TENNESSEE VALLEY AUTHORITY  
BROWNS FERRY NUCLEAR PLANT (BFN)  
UNITS 1, 2, AND 3

PROPOSED TECHNICAL SPECIFICATION (TS) CHANGE TS-339  
MARKED PAGES

PROPOSED TECHNICAL SPECIFICATION (TS) CHANGE TS-339  
REVISED PAGES

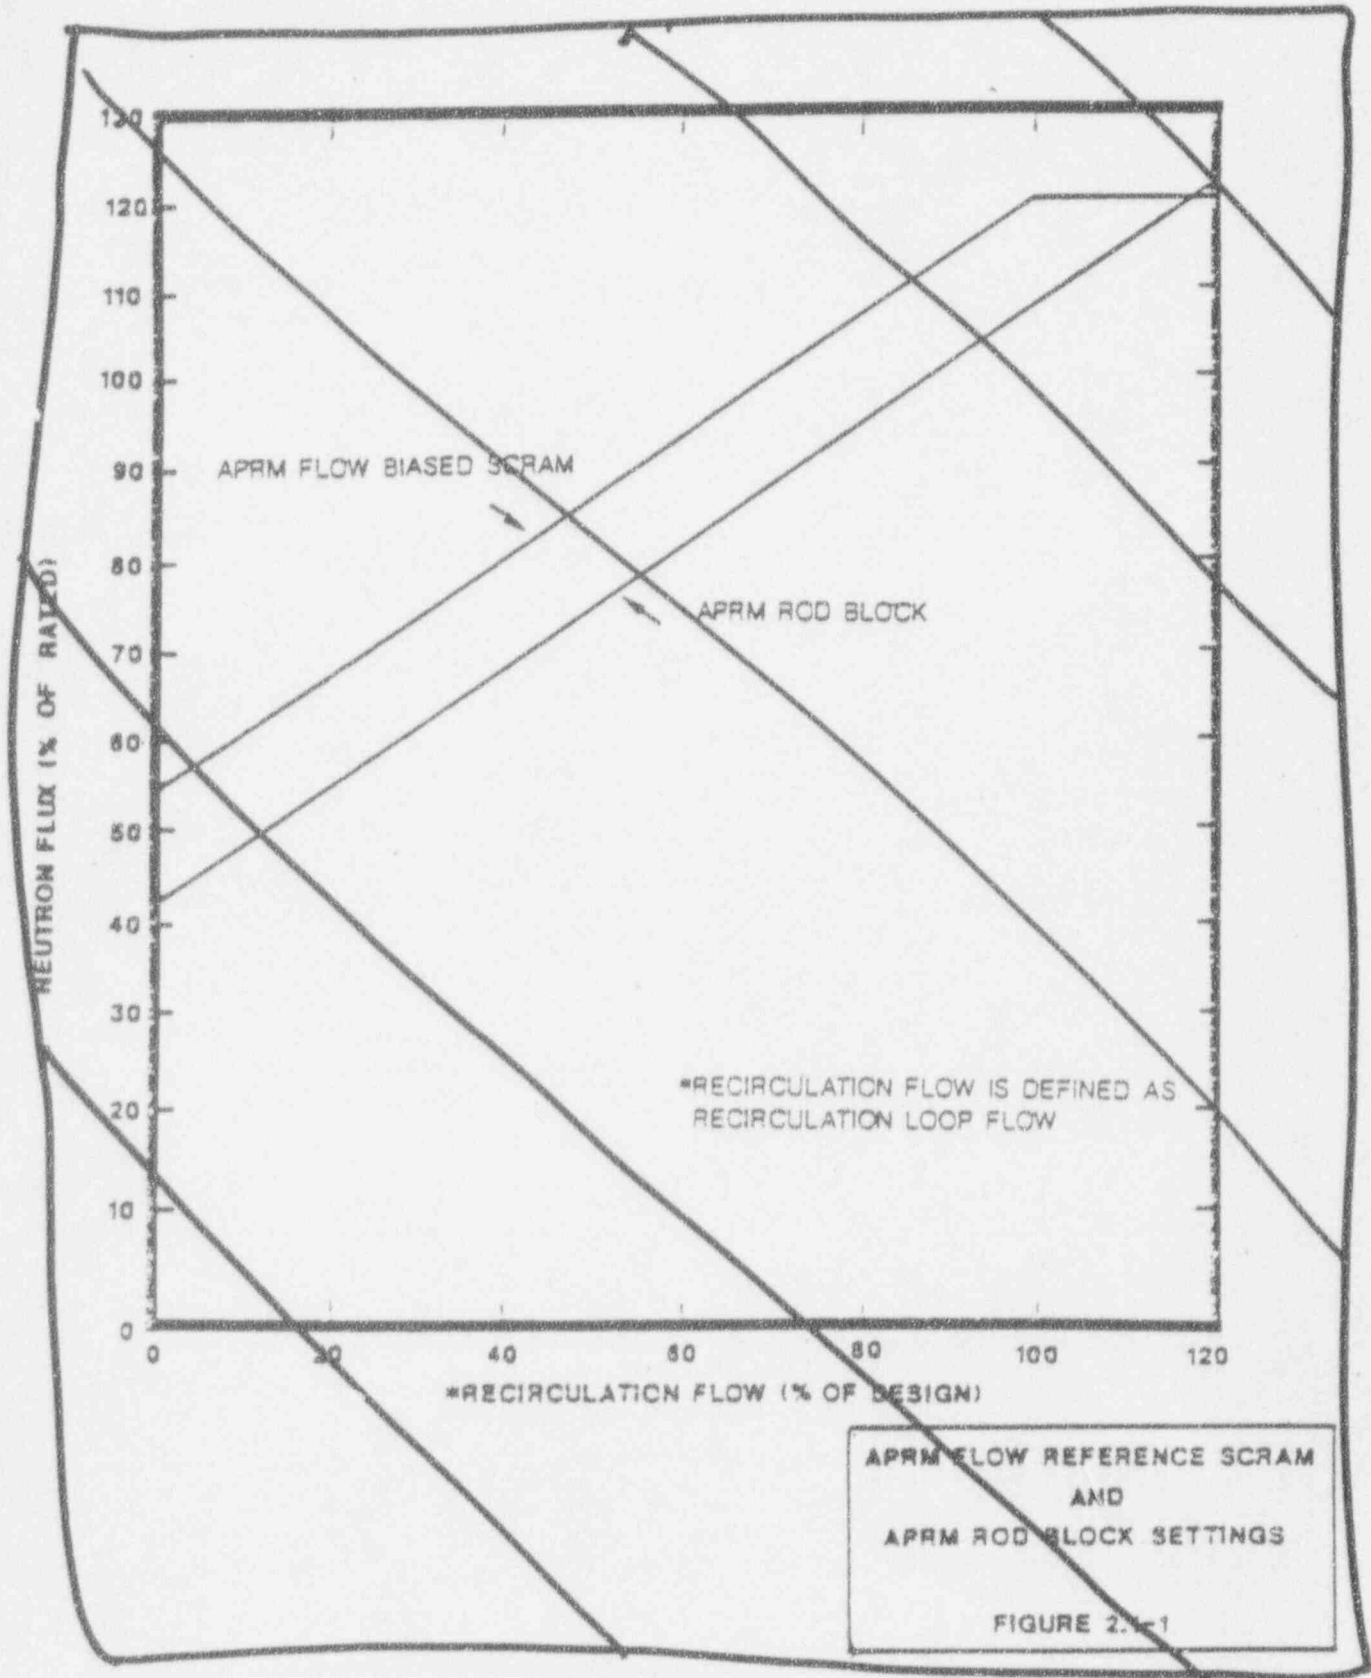
- c. The APRM Rod Block trip setting shall be  $X$

$$SRB \leq (0.66W + 42\%)$$

less than or equal to the limit specified in the CORE OPERATING LIMITS REPORT.

APRM FLOW BIAS SCRAM Vs. REACTOR CORE FLOW  
Fig. 2.1-2

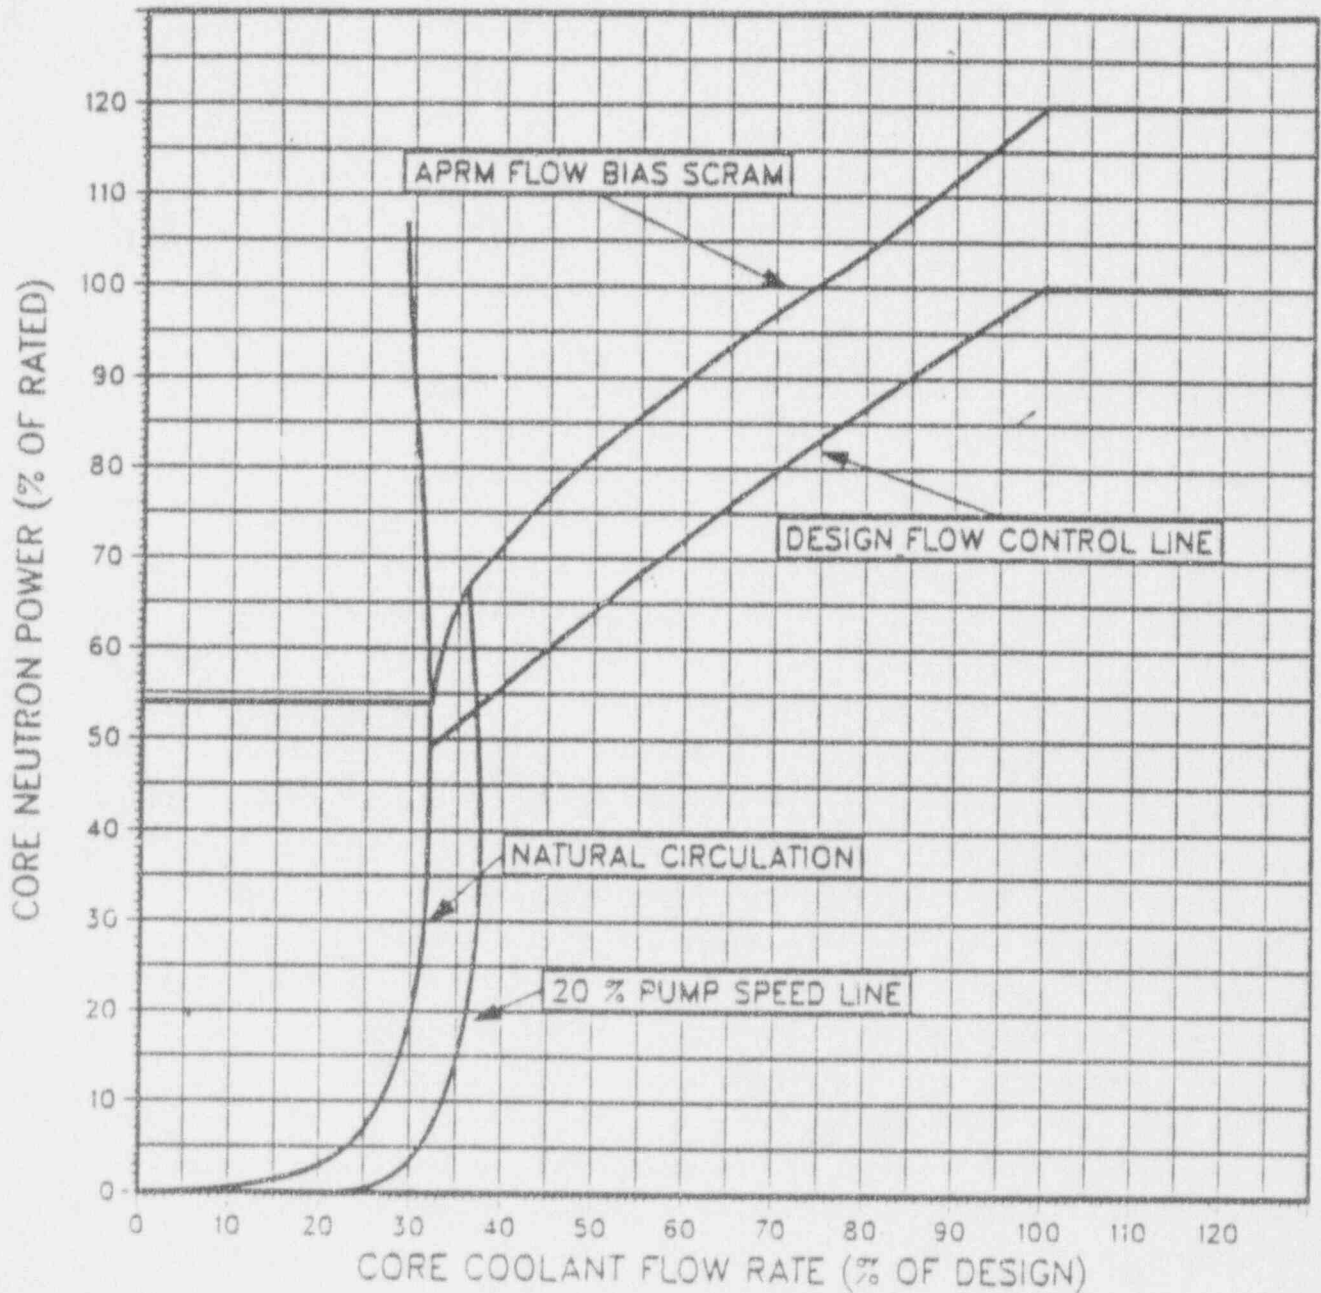
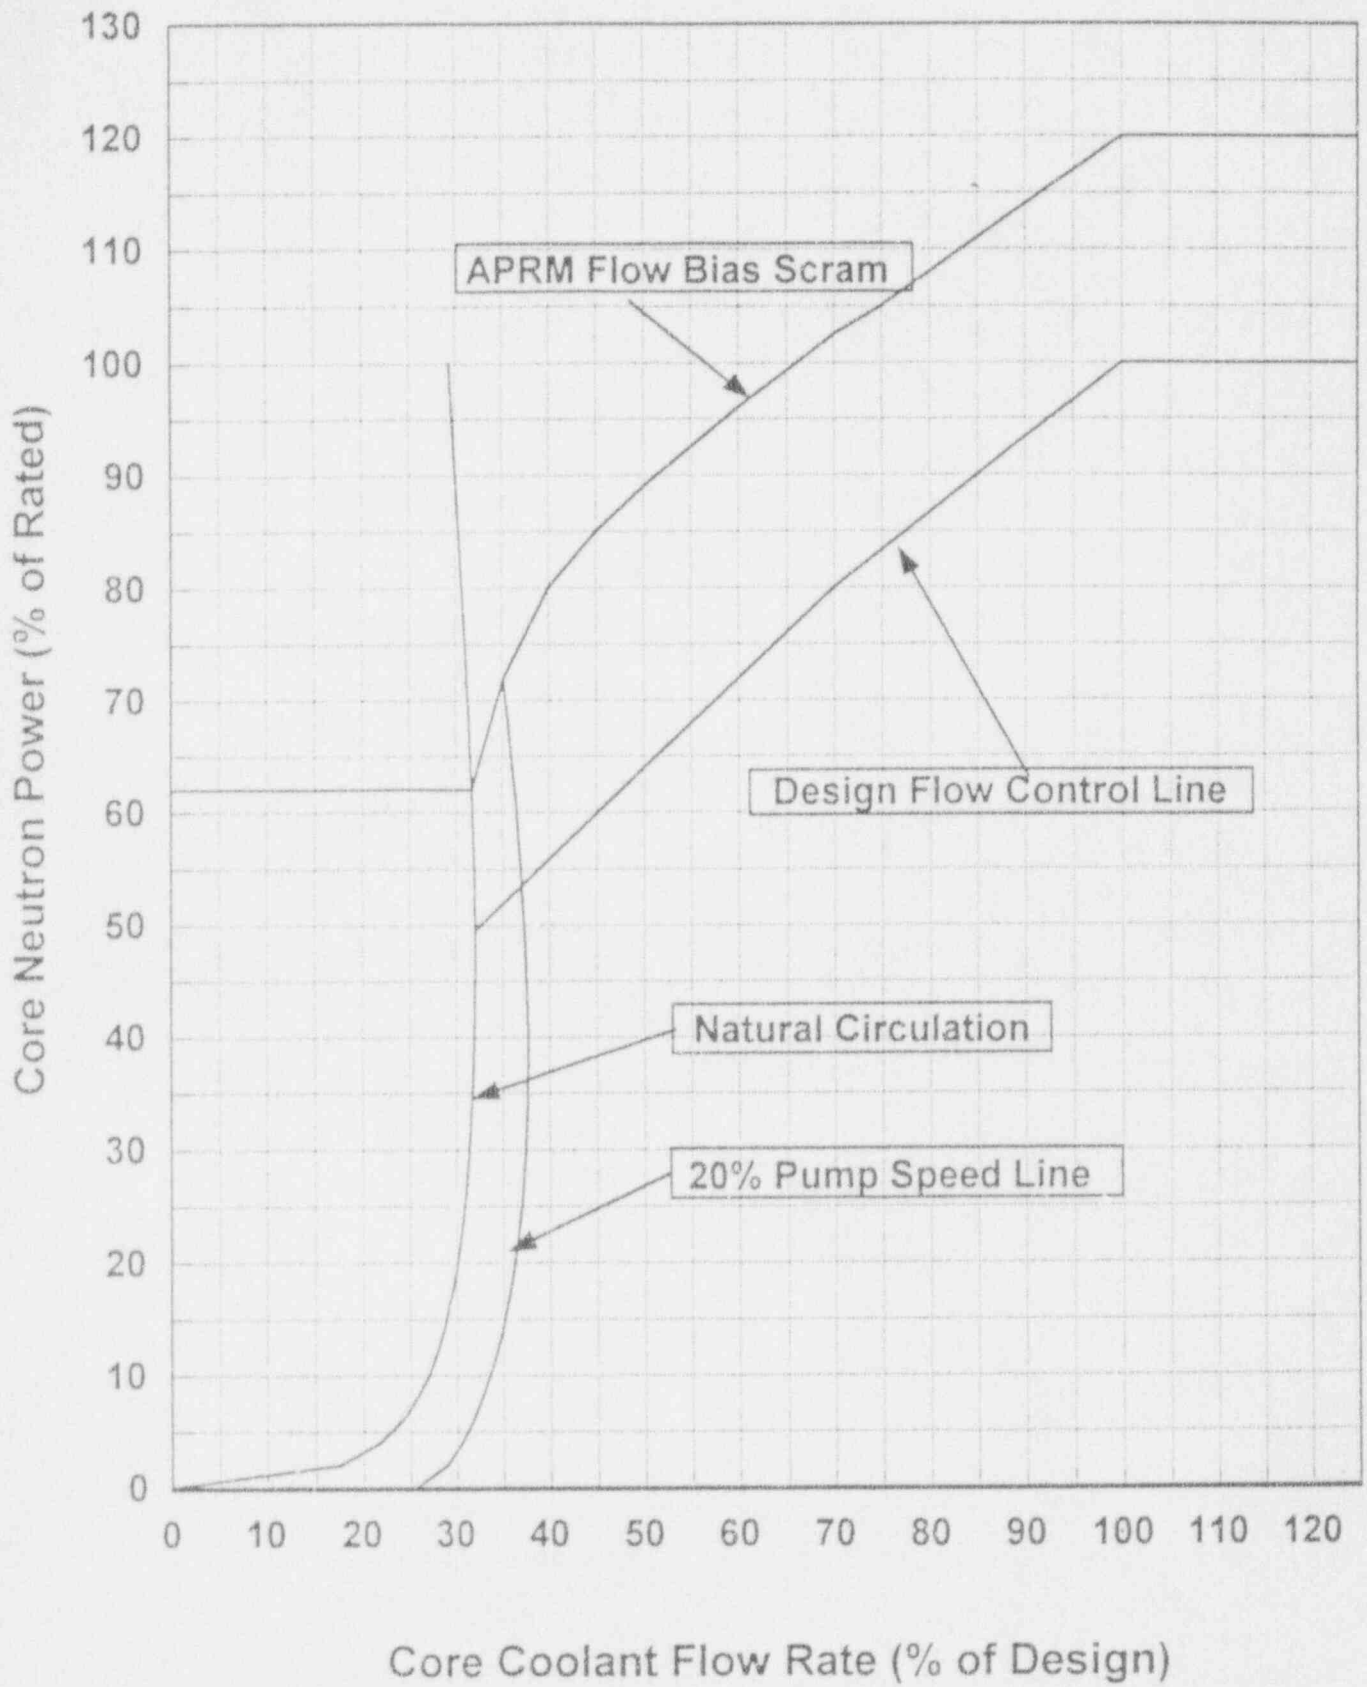
DELETE THIS FIGURE

REPLACE THIS FIGURE WITH  
NEW FIGURE ON FOLLOWING PAGE

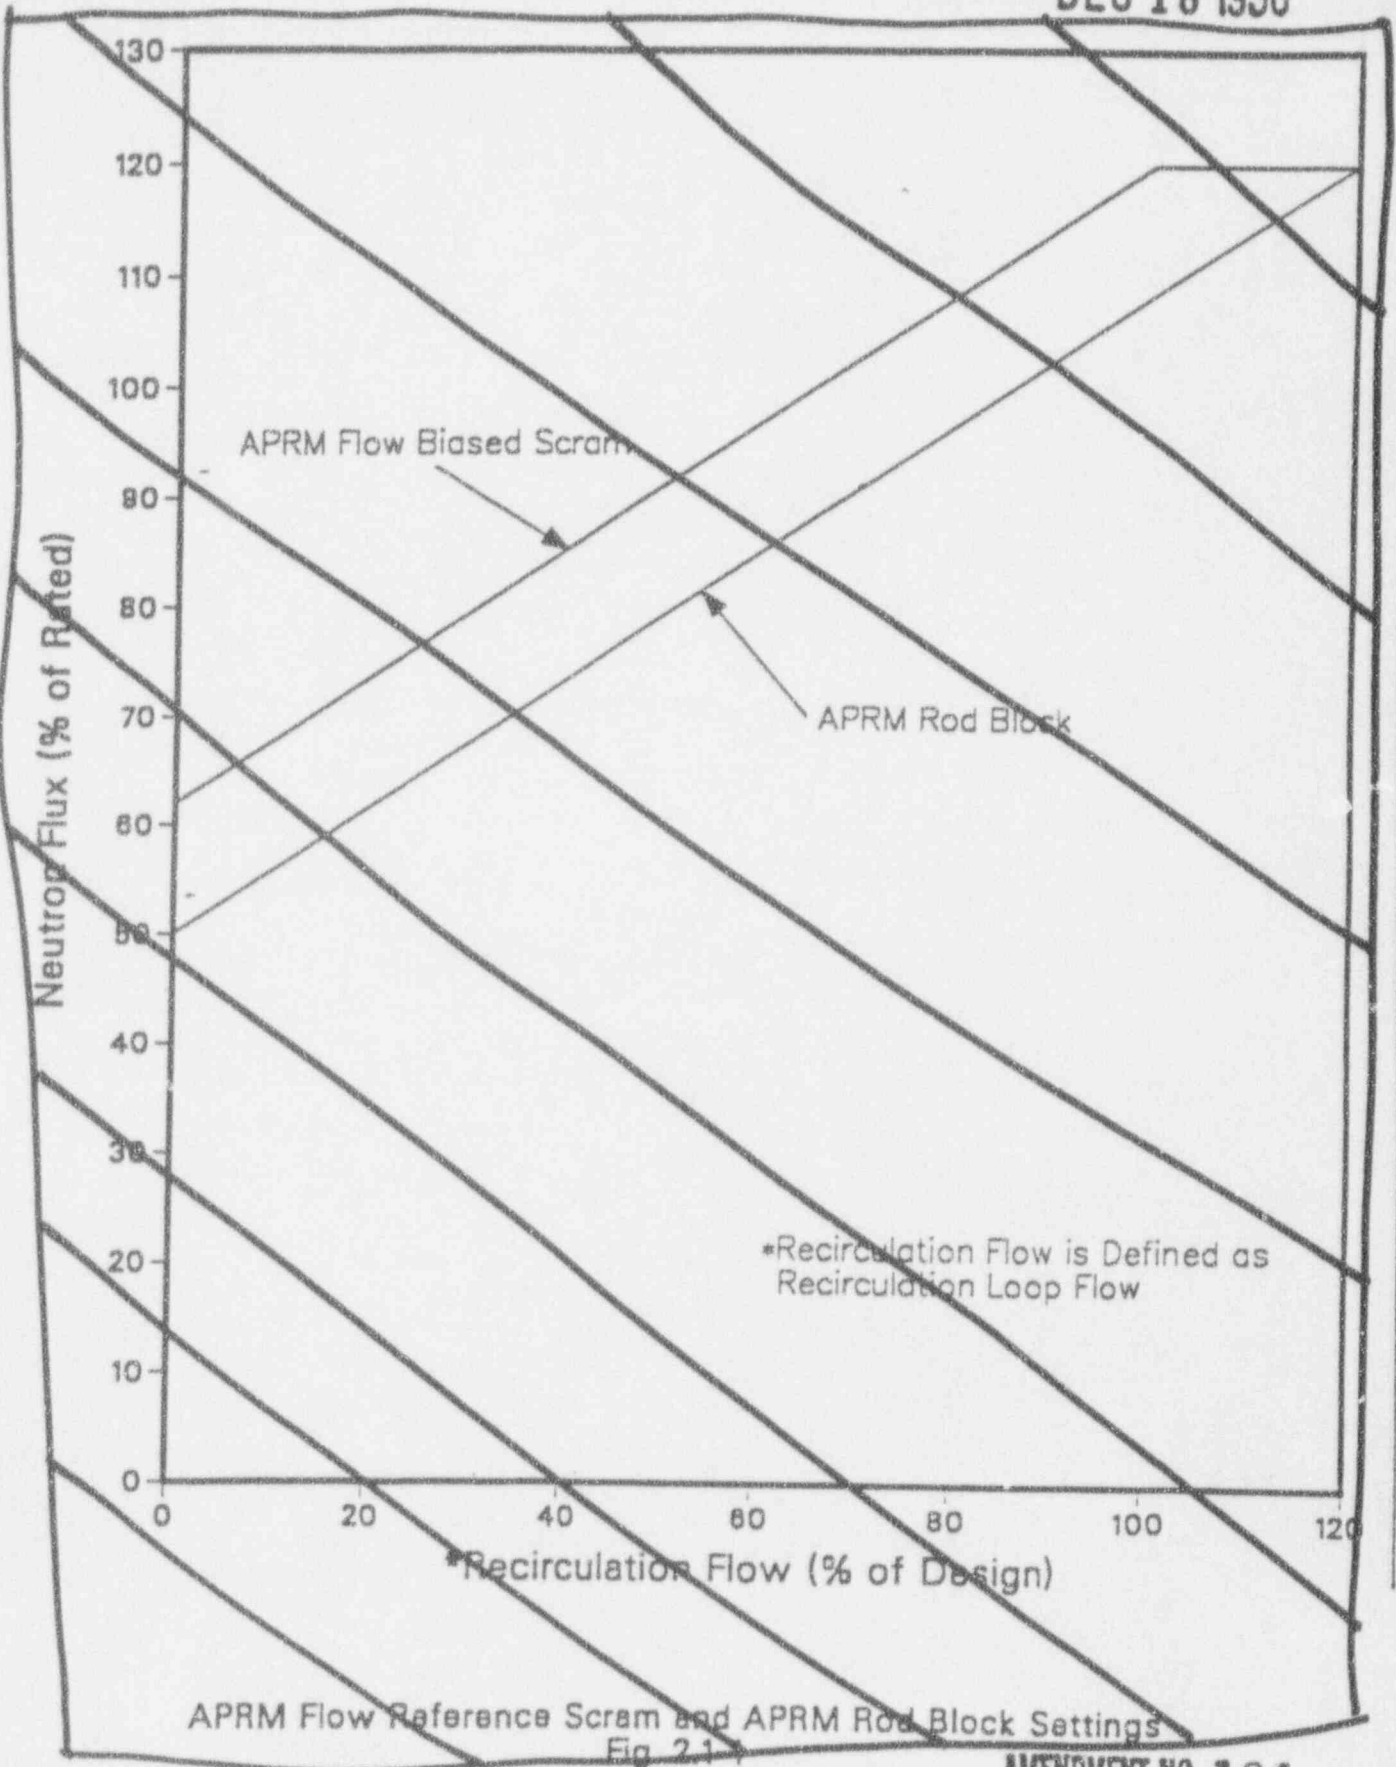
- c. The APRM Rod Block trip setting shall be ~~X~~

$$S_{RB} \leq (0.58W + 50\%)$$

**DELETE THIS FIGURE**

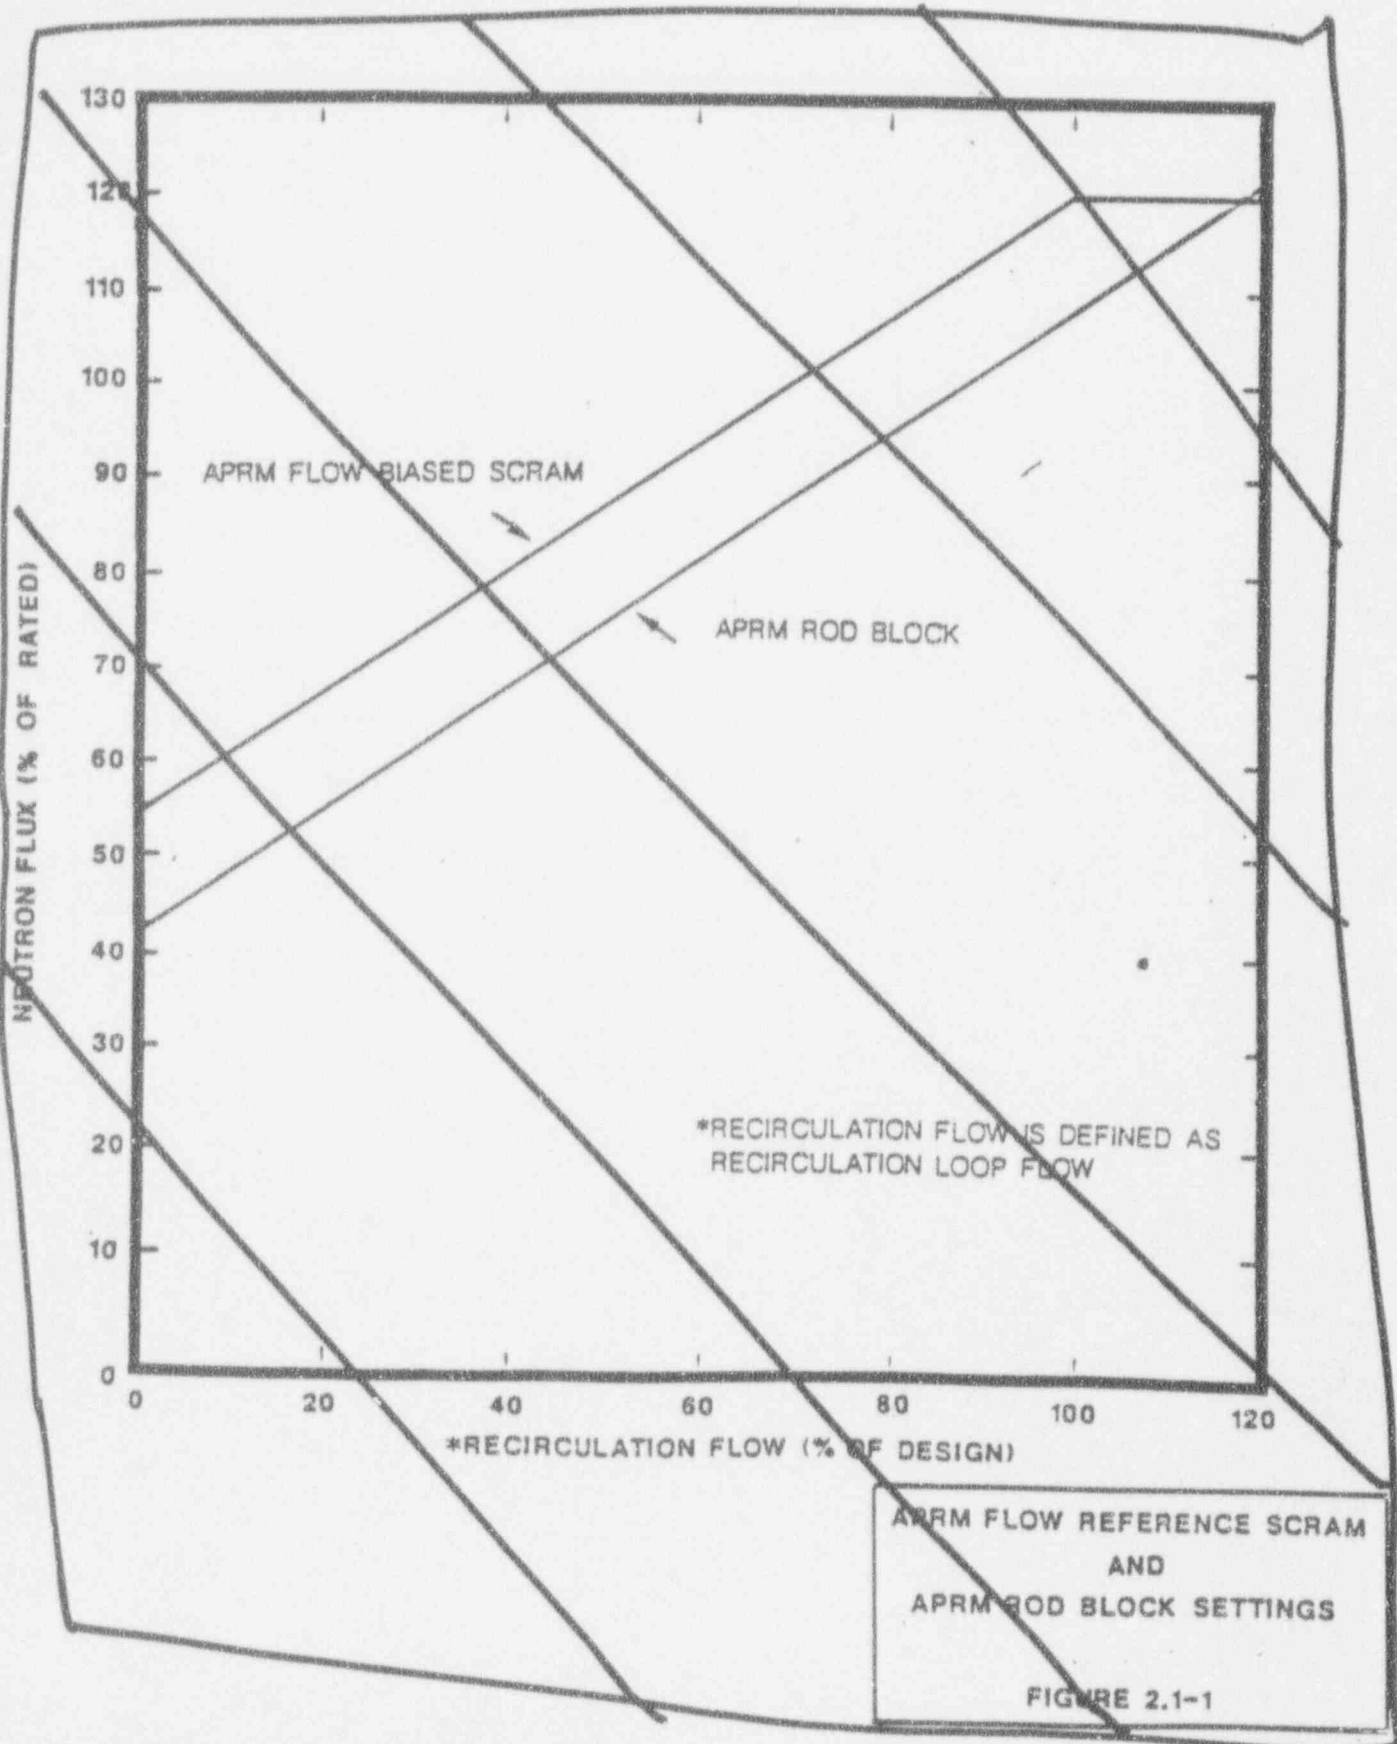
$$S_{RB} \leq (0.66W + 42\%)$$

less than or equal to the limit specified in the CORE OPERATING LIMITS REPORT.
